# 1ZZ-FE Engine Oil Level Specification Update

The 1ZZ-FE engine oil capacity and oil level gauge assembly (dipstick) has been updated for specific model year Celica, Corolla, and Matrix vehicles. Refer to the information below for the updated capacity and part number information.

**Figure 1.**

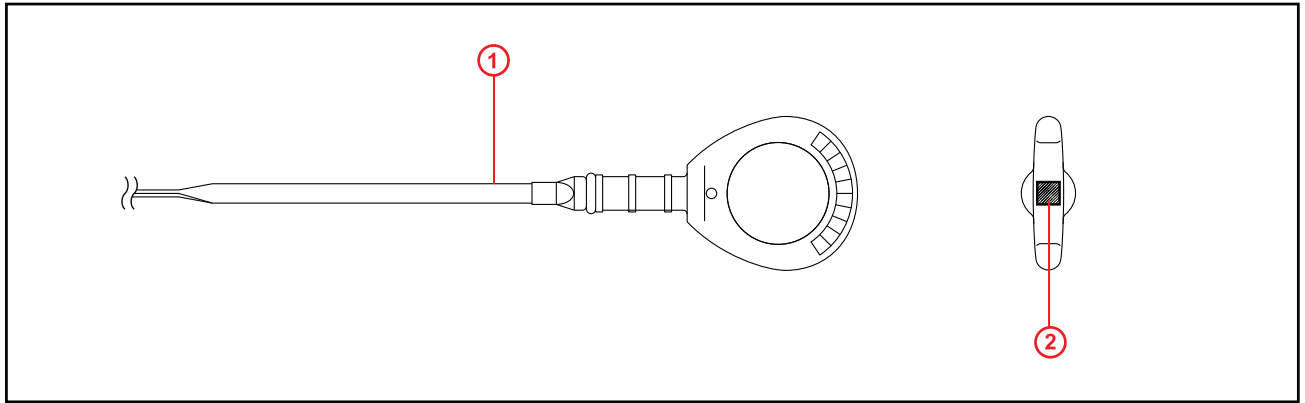
The updated oil level dipstick has an identification mark as indicated in Figure 1.

PREVIOUS PART NUMBER	CURRENT PART NUMBER	PART NAME	QTY
15301-22030	15301-22050	Gauge Sub-assembly, Oil Level	1
